Access Compliance Report

Public Rights-of-Way

(Curb Ramps)

Intersection ID: 10027410	Main Street: GOLF_ACRES_DR	Cross Street: N/A	Location: SW
ADA ID: D169E8E0F0B3	Ramp Type: BlendTrans1	Initial Pass/Fail: Fail	Overall Compliance: No
		Severity Score: 10

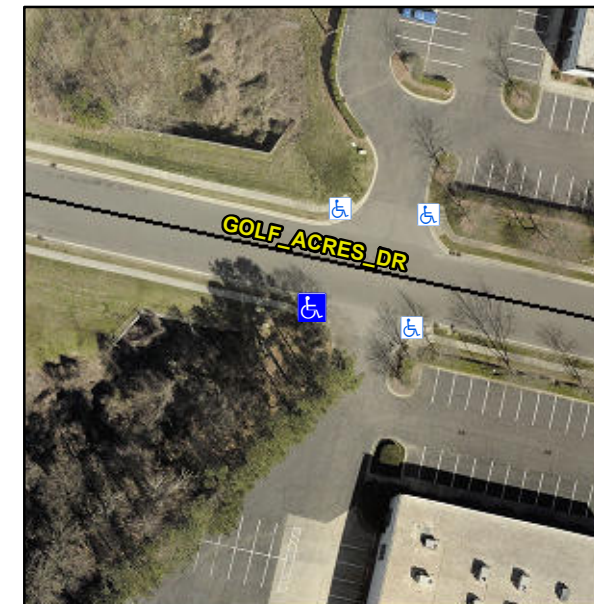
Not Found, R304.5.1, R304.5.3

Compliance	Description	Data	Compliance	Description	Data
N/A	Ramp Length (in)	47.5	Yes	BlendTrans Slope (%)	4.1
No	Ramp Width (in)	44.0	No	BlendTrans XSlope (%)	3.6
N/A	Flare Type LT	N/A	N/A	Flare Type RT	N/A
N/A	Flare Slope LT (%)	N/A	N/A	Flare Slope RT (%)	N/A
N/A	Flare Traversable LT?	N/A	N/A	Flare Traversable RT?	N/A
N/A	Landing Length (in)	N/A	N/A	DWS Provided?	N/A
N/A	Landing Width (in)	N/A	N/A	DWS Contrast?	N/A
N/A	Landing Slope (%)	N/A	N/A	DWS Length (in)	N/A
N/A	Landing X Slope (%)	N/A	N/A	DWS Full Width?	N/A
N/A	Landing Curb? (Y/N)	N/A	N/A	DWS Offset (in)	N/A
N/A	Shared Landing?	N/A			
N/A	Gutter Ponding?	N/A	N/A	Gutter Slope (%)	N/A
N/A	Gutter Lip Ht (in)	N/A	N/A	Gutter X Slope (%)	N/A
N/A	Painted X Walk1?	No	N/A	Painted X Walk2?	No
	X Walk 1 Direction	To E		X Walk 2 Direction	To N
	X Walk 1 Width (in)	N/A		X Walk 2 Width (in)	N/A
	X Walk 1 Slope (%)	3.1		X Walk 2 Slope (%)	4.2
	X Walk 1 X Slope (%)	2.9		X Walk 2 X Slope (%)	4.5

N/A	Ramp inside XWalk1?	N/A	N/A	Ramp inside XWalk2?	N/A
	Road Slope (%)	0.4		Clear Space?	N/A
	Road X Slope (%)	5.4	N/A	Clear Space to XWalk (in)	N/A
N/A	Any Obstructions?	N/A	N/A	Storm Grate/Utility Hazard?	N/A
	Obstruction Type			Storm Grate/Utility Type	
		N/A			N/A
			Yes	Surface Condition? (G/P)	Good
			No	Curb Slope (%)	11.3

Remove & Replace Curb Ramp With Two New Directional Ramps or Equivalent.
